## Informational Bulletin

## ENHANCED VAPOR RECOVERY

### Minimizing Wintertime In-Station Diagnostic System Overpressure Alarms

December 4, 2017

**Figure 1: EOR and Previously Certified Spout Assembly (horizontal view)**

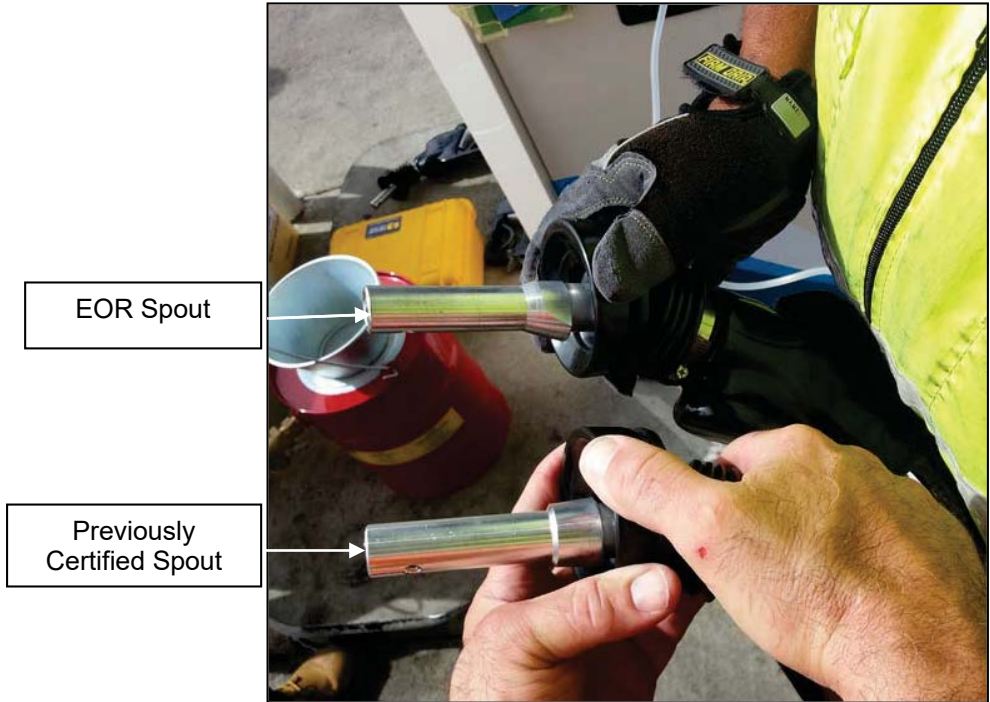
In response to these findings in 2015, Franklin Fueling Systems (FFS), manufacturer of the assist system, made design enhancements to the spout assembly of the assist nozzle. These improvements enable a better seal between the nozzle's vapor collection boot and the vehicle fill pipe, thereby reducing excess air ingestion. The new spout assembly, referred to as Enhanced ORVR-Vehicle Recognition (EOR), is depicted in Figures 1 and 2 and can be field retrofitted onto existing nozzle bodies. During the winter of 2016/2017, CARB staff evaluated the performance of the EOR spout assembly at eight GDFs, each with

differing operating conditions. On August 23, 2017, the new spout assembly was certified by CARB per "Revision V" of Executive Orders [VR-201](#) and [VR-202](#). Although CARB certified the EOR spout assemblies, either field retrofitted or factory new nozzles, CARB staff determined that the factory new nozzles outperformed field retrofitted nozzles and therefore, suggest installation of factory new nozzles.

1. Replace existing assist nozzles with the new (factory assembled) nozzles equipped with the EOR spout assembly according to Section 2 of the CARB Approved Installation, Operation and Maintenance Manual (IOM) for the assist system. The new EOR nozzles are anticipated to be available from FFS in January 2018.
